<b>Subject:</b>  KNOCKING NOISE FROM FRONT SUSPENSION	<b>Bulletin No.:</b> 02-002/25
	<b>Last Issued :</b> 07/03/2025

2024 CX-90 with VINS lower than JM3KK\*\*\*\*\*161943 (produced before March 11, 2024)

2025 CX-70 with VINS lower than JM3KJ\*\*\*\*\*101830 (produced before March 16, 2024)

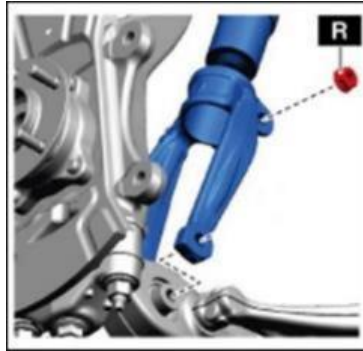
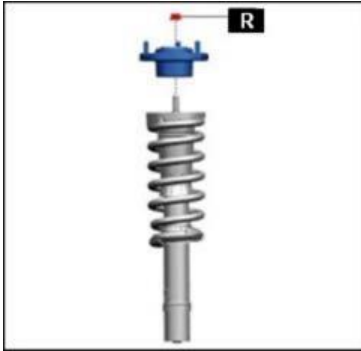
Some vehicles may experience a knocking noise from the front suspension when driving on a rough road or traveling over bumps. This noise is caused by a gap between the front strut bump stopper and the mounting rubber that is pushed up when roads are bumpy. To eliminate this concern, the outer diameter of the bump stopper has been modified to prevent the knocking sound during driving on a rough road or traveling over bumps.

3. Replace the front strut bump stoppers with the modified ones.
4. Assemble and install the front shock absorber and coil spring in the reverse order of removal.
5. Verify the repair.

Parts Number	Description	Qty.	Notes
KBB6-34-111A	Stopper, Bump	2	
KBB6-34-380B	Rubber, Mounting	2	If needed
9YB04-1237	Nut	2	[R] Piston rod nut
9YB10-1212	Nut	2	[R] For damper fork
